Access Compliance Report
Public Rights-of-Way
(Pedestrian Signals)

ADA ID: 66D890BA1DAC **Signal Type:** One Push Button-Non APS **Overall Compliance:** No **Severity Score:** BTN 1: N/A BTN 2: N/A No BTN: N/A

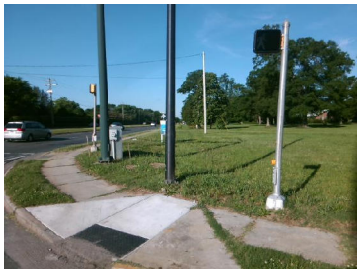
Surveyor Notes: TEXT HT 3/9

PROW/ADA: R410.6, TMUTCD 4e.08, R404.2, R404.3, R406.2, R404.7.3

Possible Solutions: Replace Signal Push Button With APS Button on New Post. Remove & Replace Sign.
